Response to:

210077/PREAPP at 75-77 London Street and Land to Rear
Pre-Application Advice for Proposed demolition of buildings to rear (Olympia Hall) and erection of 12 flats with associated parking, landscaping and courtyard garden and conversion of ground floor of no.s75-77 to 3 flats

Our Ref: 210077/PREAPP

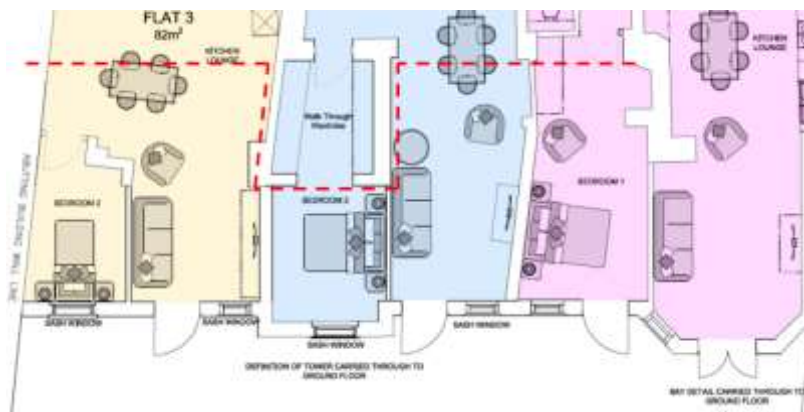
No details of any internal alterations to the ground floor of the buildings to facilitate the conversion to three flats have been provided and the submitted Heritage Briefing Note does not explain the significance of the internals of this part of the building. As such comments are not provided on this element of the proposals, but the strong presumption is that original fabric of the buildings should be retained and incorporated as part of the proposed conversion

- As detailed on (REV G - PART 1 - LISTED BUILDING PROPOSAL - EXISTING & PROPOSED PLAN & ELEVATION) the existing fabric of the ground floor is to be retained to the greatest degree possible. Where existing walls are present, the proposal has been designed to integrate. The ground floor extension extends past the historic fabric of Listed 75-77, shown below in red dashed line, highlighting the historic fabric of the tower, which continues to the roof.

Even past this point existing walls are retained, resulting in a layout that is heavily influenced by the placement of historic fabric, even if potentially more recent in formation.

Heritage Clay Plain Roof Tile - Birchwood Mix

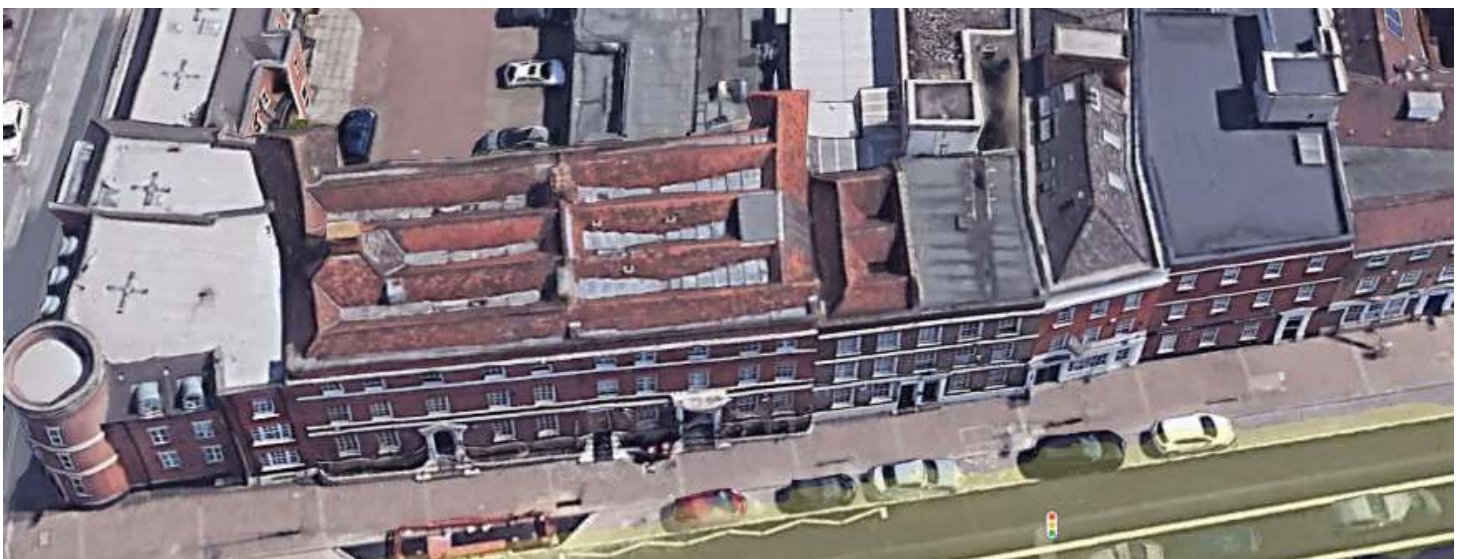
Little detail of the detailed design of the proposed new build rear building is provided within the pre-application design pack. In terms of materials, it is considered that red brick should be the primary finish for the new buildings and that any development should pick up on the design characteristics of the frontage buildings, such as slim profile Georgian windows, sills and gauged brick header lintel detailing and slate roofs.

Materials for the proposed flats includes:

- Red brick for the primary finish for the new buildings
- Georgian windows, sills and gauged brick header lintel detailing to match 75-77 London street

Aldwick Blend brick - Traditional thrown / stock / soft mud brick that is red in colour with a light texture.

As for the roof, we intend to match the existing 75-77 London street using a heritage clay plain roof tile. Details of roof and brick selection below.

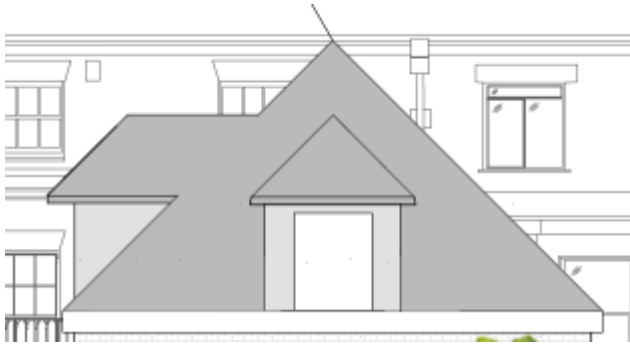
Attention should be paid to window proportions, and it is expected should reduce to upper floors which is also reflected in the appearance of the existing frontage buildings. Dormer roof projections are also indicated – the scale of these projections should be kept to a minimum such as not to dominate the roof space and their design should be carefully handled using traditional materials (slate-hanging, leaded cheeks etc).

- Window fenestration to closely match existing, reducing on 1st floor.
- Dormer windows to roof reduced in scale from previous proposal, below on left. Now utilizing Leaded cheeks.
